*P.D. 09-302 CC (formerly P.D. 01-331 CC  
Cordova Ridge Planned Development, 4<sup>th</sup> Amendment*

**Cordova Ridge P.D.**

**Cordova Ridge P.D. Outline Plan Modification**  
**Response to LRK's comments dated 05-07-09**

# July 18, 2009 Concept Plan Cordova Ridge P.D. SHELBY COUNTY, TENNESSEE

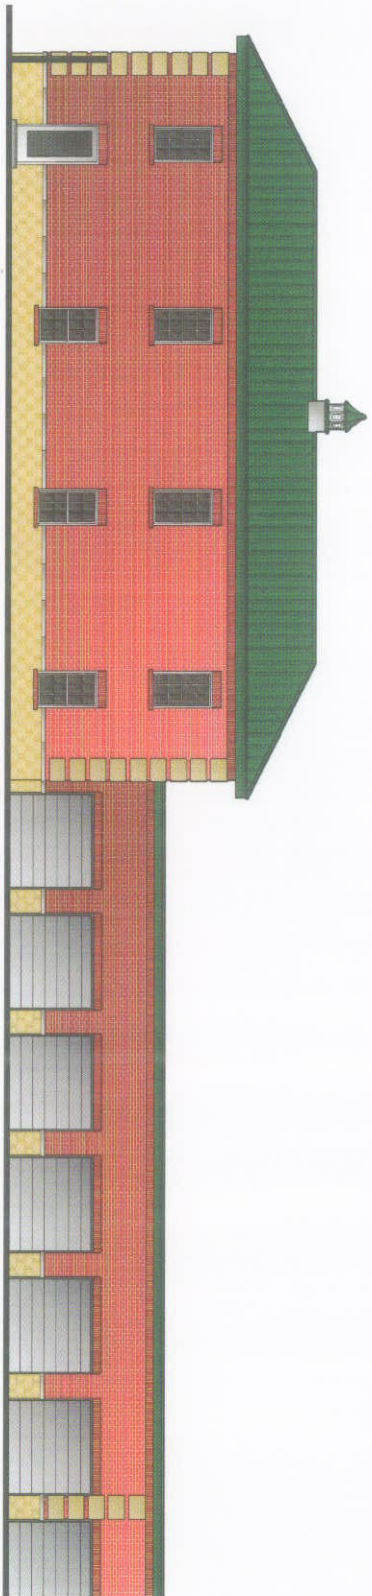
- (1) Comment: *Open view to storage with no landscape screen (traveling east on Macon Road).*

- (2) Comment: *Negative view traveling west on Macon Road.*

- (3) Comment: *Site Plan locates commercial use parking lot adjacent to residential homes and yards.*

- (4) Comment: *25-foot landscaping screen (along east line of parcel) is not adequate for such conflicting uses. Suggest a 40-foot screen.*

- (5) Comment: *No connection commercial use to commercial use. Burdens Macon Road.*
- Response: The concept plan absolutely does connect the subject parcel with the commercial parcel adjacent to the west (Kroger). The existing drive located on Macon at Kroger's east line will be shared with and provide access to the site.

- (6) Comment: *Minimum 20-foot wide planting area for street scape along Macon Road. 11-feet is too narrow to sustain hardwood street trees.*
- Response: Standard plate A-3 is required by the approved P.D. and has been the typical requirement for many years. The applicant is opposed to the placement of arbitrary requirements or conditions on its property.

- Again, Parcels 1, 2 and 3 are not a part of this application.
- (7) Comment: *Extend the front yard setback dimension of the adjacent residential homes into Parcel 2 as a landscape area and plant with hardwoods.*

- Response: The applicant is opposed to this 'taking' of its property.
- Parcel 2 is not a part of this application.
- (8) Comment: *Outdoor R.V. parking area is exposed to residential street creating a negative view.*

- (9) Comment: *Why cul-de-sac if street was designed to connect? Obvious intent was to connect Sterling Ridge Drive.*
- Response: The adjacent neighborhood (Cordova Ridge P.D. Phase 7) is only 11.2 acres in size and was originally designated for office uses. When it became apparent that the demand for office along this portion of the Macon corridor was low the County allowed this property to be rezoned for residential uses. Please note that this subdivision has no connectivity to any of the surrounding neighborhoods and has two points of access to Macon Road.

- (10) Comment: *Storage buildings shall not extend (northward) beyond front of building on parcel 3 and in no case ever beyond the side of Kroger.*

Response: First, the concept plan is sensitive to the surrounding area by using a very narrow entrance on Macon Road. The entry is only 55 feet wide when most mini-warehouse developments use 100 feet or more.

Second, it is not typical to install heavy landscape screening between adjacent commercial uses. Once the vacant out parcels in front of Kroger along Macon Road develop, the sight lines as sketched will be blocked. It would be very short sighted to impose the burden of a commercial-to-commercial landscape screen to address a temporary aesthetic sight line concern.

Response: Again, the proposed architecture for the mini-warehouse building elevations will be all masonry so the view while traveling west on Macon will effectively be a brick wall with an eight-foot evergreen screen in front. This would not create a negative view looking west into the site.

Response: Parcels 1, 2, and 3 are not a part of this application and are shown on the concept plan for illustrative purposes only. Parcel 4 is the only portion of the property for which the additional mini-warehouse use is being added. The balance of the property (Parcels 1, 2, and 3) will remain as previously approved. It should be noted that the 25-foot landscape screen (with sight proof fence) shown along the east boundary of Parcels 2 and 3 is 10-feet wider than the 15-foot screen required by the approved planned development and meets the specifically referenced landscape requirement in ZTA 96-002CC.

Response: See response to Comment (3). The applicant is opposed to a 40-foot landscape screen along the east line.

- Response: The fully developed cul-de-sac shown on the concept plan is superior to the undersized patch of asphalt that currently exists. The residents currently have a view of the rear of the Kroger store.

- The concept plan proposes the planting of a 25-foot wide landscape screen completely around the head of the cove. The screen will include a sight proof fence. This plan represents a dramatic improvement of the existing condition.

Any extension of Sterling Ridge Drive through the subject commercial property would damage and potentially destroy its viability for commercial uses without accomplishing any meaningful connection to the Kroger site. Due to the location of Kroger's detention pond Sterling Ridge Drive cannot be extended to the west and creating another public street intersection in Macon Road east of the Kroger site would be expensive, effectively pointless and extremely disruptive to the orderly development of the applicant's site.

Response: This condition is unacceptable because it provides no presence along Macon Road for the mini-warehouse site. Additionally, the alternate site configuration presented is not practical because it does not allow for ingress and egress of moving vehicles into and out of the storage facility without driving through parking lots designated for service to the retail component of the development. The alternate site plan does not appear to provide proper turning radii to accommodate typical moving vehicles.
